# UNITED STATES PATENT AND TRADEMARK OFFICE

APPLICATION NO.	FILING DATE	FIRST NAMED INVENTOR	ATTORNEY DOCKET NO.	CONFIRMATION NO.
10/691,921	10/23/2003	Yvan A. Couillais	60,152-990	1616

## Office Action Summary

## **DETAILED ACTION**

US-1,363,104 Foss Figure 2 shows an identical structure to the instant claims 1, 2, and 4  
(element 9 integral with 10 supported by pin 8)

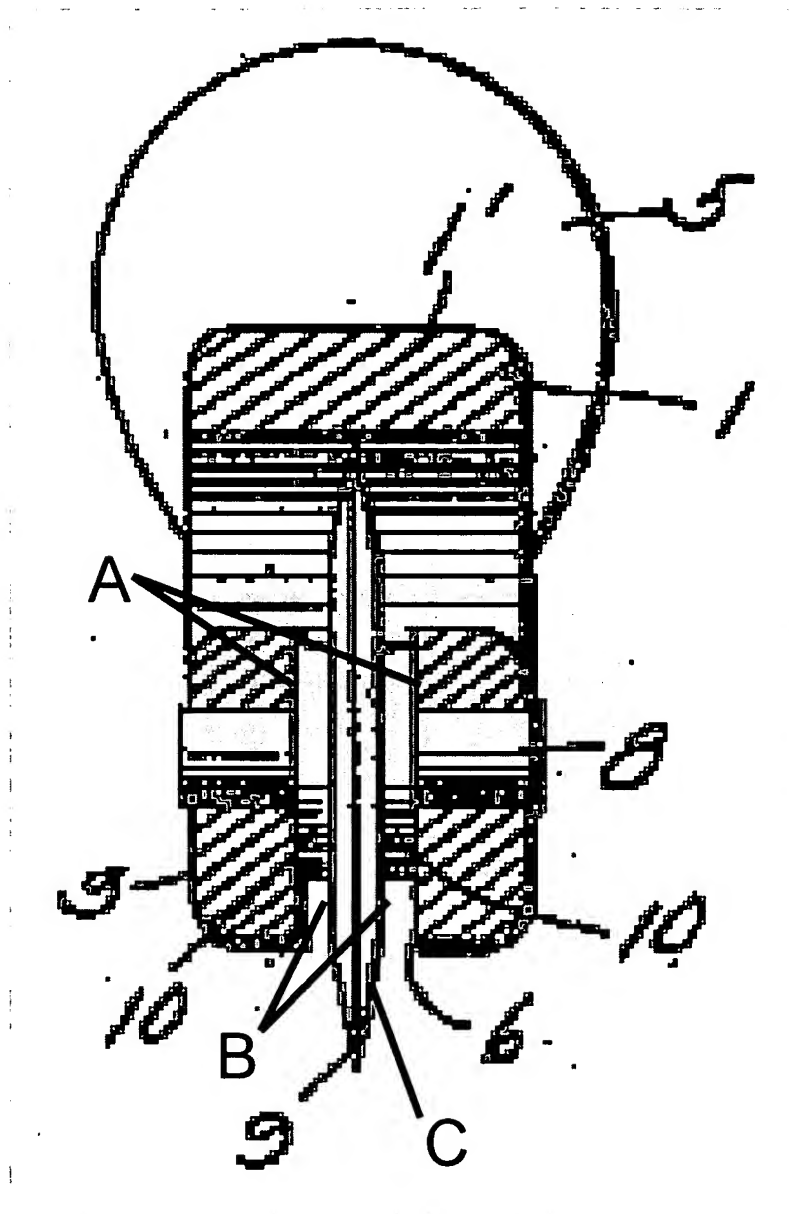
[6] Claims 1, 2, and 4 rejected under 35 U.S.C. 102(b) as being anticipated by Foss US-1,363,104. Foss teaches an element inherently capable of fastening in the manner disclosed in the instant specification, comprising:

a body portion (10) having opposed ends (A) and a bore (hole in which pin 8 travels through) extending through said body portion (10) through said opposed ends (A);  
and a radial flange portion (9) integral with said body portion (10) midway between said opposed ends (A) having generally parallel planar annular surfaces (B) on opposed sides of said radial flange portion (9) surrounding said body portion (10) and an inwardly tapered annular outer peripheral portion (C).

As for Claim 2, the element 'is symmetrical about a plane perpendicular to a longitudinal axis of said bore.'

As for Claim 4, the element's 'outer peripheral portion of said radial flange portion is generally circular.'

US-1,363,104 Lee Figures 3-5 show an identical structure to the instant claims 1, 2, and 4.

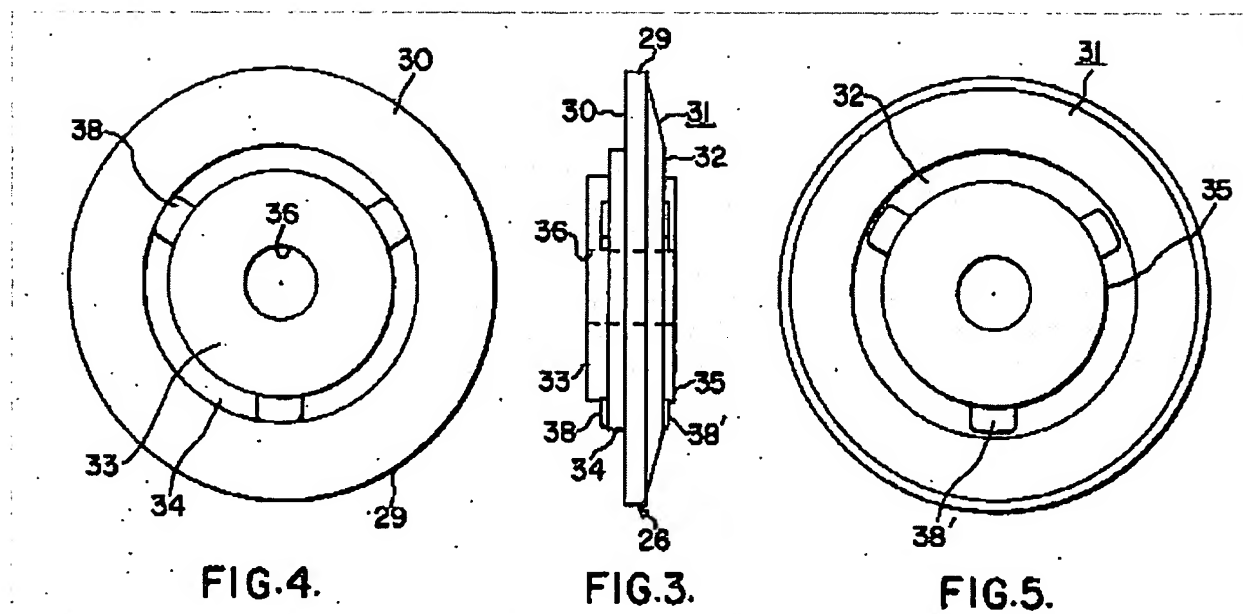
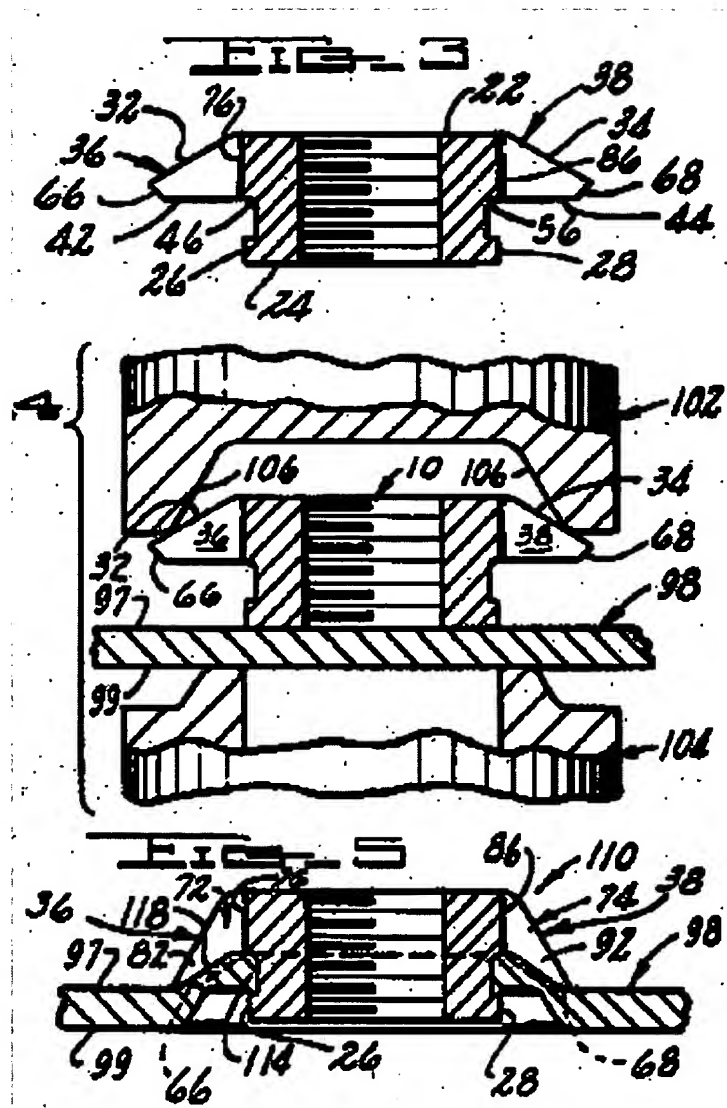
[7] Claims 1, 2, and 4 rejected under 35 U.S.C. 102(b) as being anticipated by Lee US-3,301,942. Lee teaches an element inherently capable of fastening in the manner disclosed in the instant specification, comprising:

a body portion (26) having opposed ends (33,35) and a bore (36) extending through said body portion (26) through said opposed ends (33,35);  
and a radial flange portion (29) integral with said body portion (26) midway between said opposed ends (33,35) having generally parallel planar annular surfaces (30,32) on opposed sides of said radial flange portion (29) surrounding said body portion (26) and an inwardly tapered annular outer peripheral portion (31).

As for Claim 2, the element 'is symmetrical about a plane perpendicular to a longitudinal axis of said bore.'

As for Claim 4, the element's 'outer peripheral portion of said radial flange portion is generally circular.'

US-3,187,424 Double et al Figures 3-5

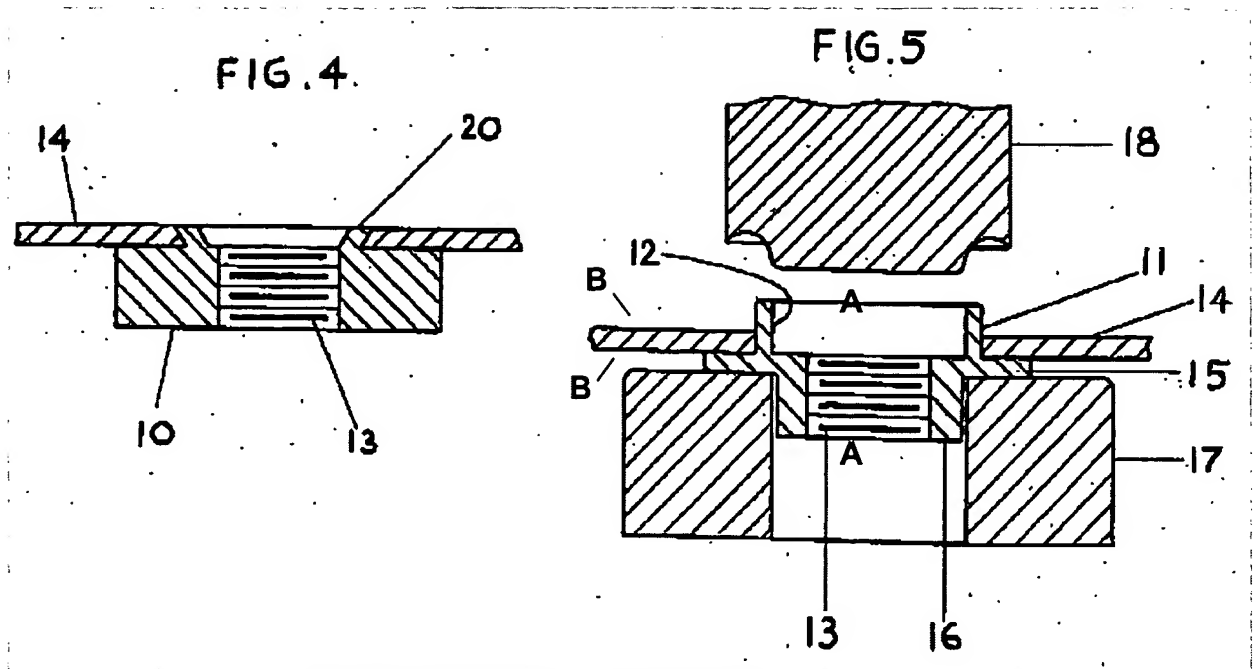
[8] Claims 16-20 are rejected under U.S.C. 102(b) as being clearly anticipated by Double et al US-3,187,424. Double et al teach:

'a method of attaching a self-attaching female fastening element to a panel (98), said female fastener element (10) including a body portion (10) having opposed end portions (22,24) and a bore (18) extending through said body portion (10) through said opposed end portions (22,24), and a radial flange portion (36,38) integral with said body portion (10) generally midway between said opposed end portions (22,24) having an annular outer peripheral portion (36, 38,66,68), said method comprising the following steps: receiving one (24) of said end portions (22,24) of said body portion (10) of said self-attaching female fastener element through an opening in a panel (Col 3 Lines 49-50); deforming said annular outer peripheral portion of said radial flange portion towards said one of said end portions of said body portion (Col 3 Lines 50-53) thereby forming an annular groove surrounding said body portion, and deforming an annular panel portion surrounding said opening in said panel into said annular groove (Col 3 Lines 58-59).'

See Figure Below. Note that the term 'generally midway' in Claim 16 Line 4 does not require the flange to be midway between the opposed ends. Also, note that the four peripheral flange extremities of Double et al. essentially make up an annular outer peripheral portion (seen best in Figure 6 not shown). A portion of an annular entity does not necessarily have to be continuous.

[9] As for Claim 17, the 'annular outer peripheral portion of the radial flange portion (36,38,66,68) includes inwardly radially tapered surfaces (66,68)', which are deformed 'toward said one (24) of said end portions (22,24) of said body portion (10) until said inwardly radially tapered surface (66,68) adjacent said one (24) of said end portions (22,24) of said body portion (10) extends generally perpendicular to a longitudinal axis of said bore (18), thereby forming an annular bearing surface supporting said panel (98)'. Column 3 Lines 63-66 of

Double et al describe this method of deforming a tapered flange so that the taper is in contact with a panel surface, roughly perpendicular to the longitudinal axis of the bore. The contact area between the tapered surfaces and the panel inherently create a bearing surface.

[10] As for Claim 20, the method taught by Double et al. 'includes driving said one end (24) of said end portions (22,24) of said body portion (10) against said panel (98) piercing said opening in said panel (98).' See Column 3, Lines 49-50.

US-2,415,695 Kann Figures 4 and 5

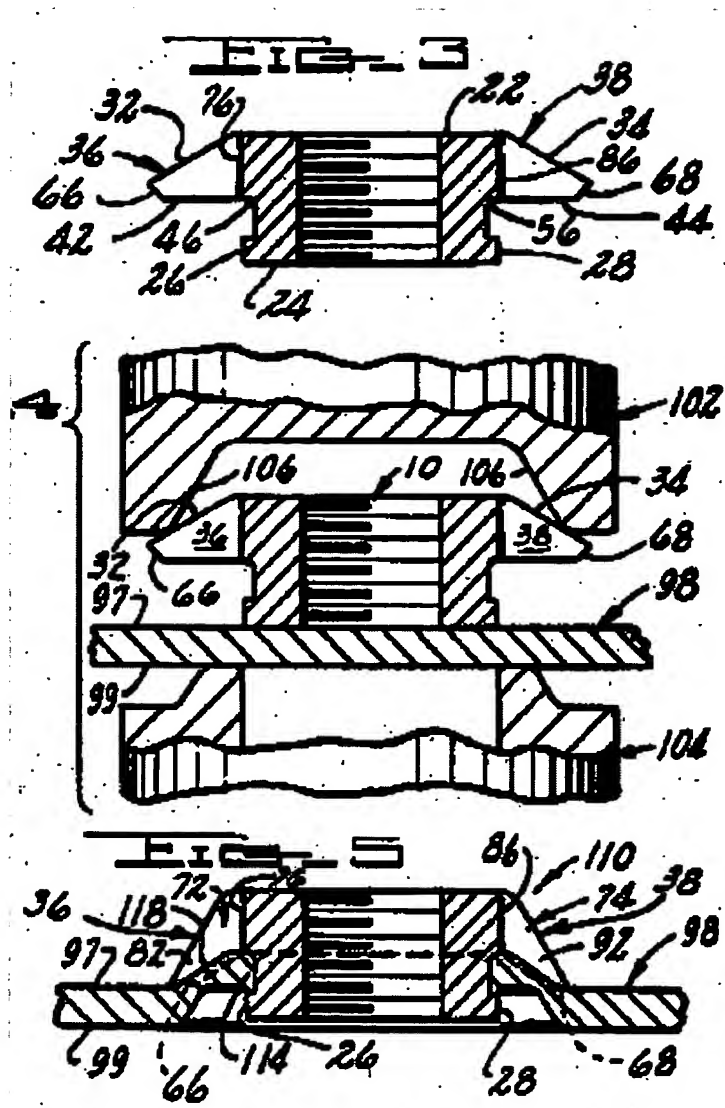
[12] Claims 1, 2, and 4 are rejected under U.S.C. 103(a) as being unpatentable over Kann US-2,415,695 in view of Double et al. US-3,187,424.

Kann teaches a self-attaching female fastening element comprising:

‘ a body portion (16) having opposed ends (A) and a bore (13) extending through said body portion (16) through said opposed ends (A);  
and a radial flange portion (15) integral with said body portion (16) midway between  
said opposed ends (A) having generally parallel planar annular surfaces (B) on opposed sides  
of said radial flange portion (15) surrounding said body portion (16).’

However, Kann fails to disclose ‘an inwardly tapered annular outer peripheral portion’ on the radial flange portion (15).

Double et al teach 'an inwardly tapered annular outer peripheral portion' on a radial flange for the purpose of providing a bearing surface after the flange is deformed towards a panel surface.

At the time of invention, it would have been obvious to one ordinarily skilled in the art, to modify the fastener taught by Kann, to include 'an inwardly tapered annular outer peripheral portion' taught by Double et al. in order to provide a bearing surface roughly perpendicular to the axis of the bore, after the flange is deformed towards a panel surface.
